Re: Florida Power & Light Company
Proposed Turkey Point Units 6 and 7
Docket Nos. 52-040 and 52-041
Response to NRC Environmental Request for Additional Information Letter
1104071 (RAI 5588) Environmental Standard Review Plan
Section 9.3.1 – Alternative Site Selection Process

Enclosure: Florida Power & Light Company, Turkey Point 6 & 7, New Nuclear Power
Generation (Formerly Project Bluegrass) Augmented Site Selection Study
Report, August 2011

NRC RAI Number: EIS 9.3.1-2 (RAI 5588)

Figure A-1, Dedicated Lands Screening Map

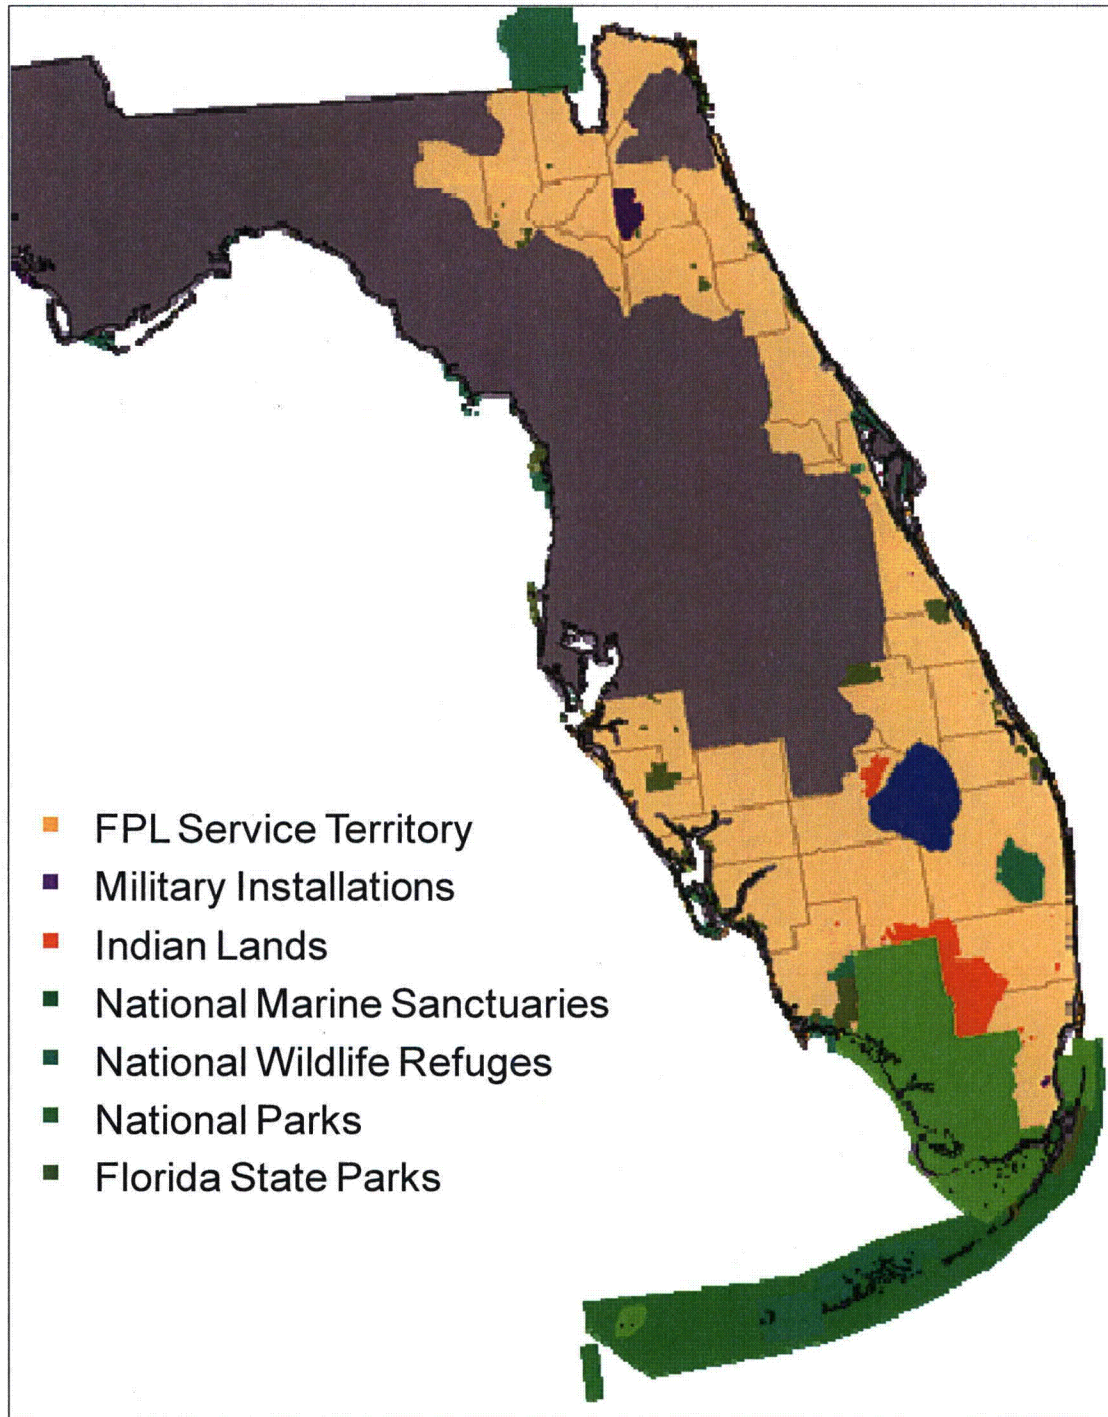
Identify the extent to which the provisions of NRC Regulatory Guide 4.7 and 10 CFR Part 100 were incorporated into FPL's site screening methodology (ESRP 9.3). Provide a formal hard copy of the geographical information system (GIS) information submitted to the reading room by the applicant.

- Figure A-1, Dedicated Lands;
- Figure A-2, Critical Habitat;
- Figure A-3, Population;
- Figure A-4, Reclaimed Water Availability; and
- Figure A-5, Surface Water Availability.

Figure A-1 depicts the results of screening the FPL service territory region of interest for dedicated lands.
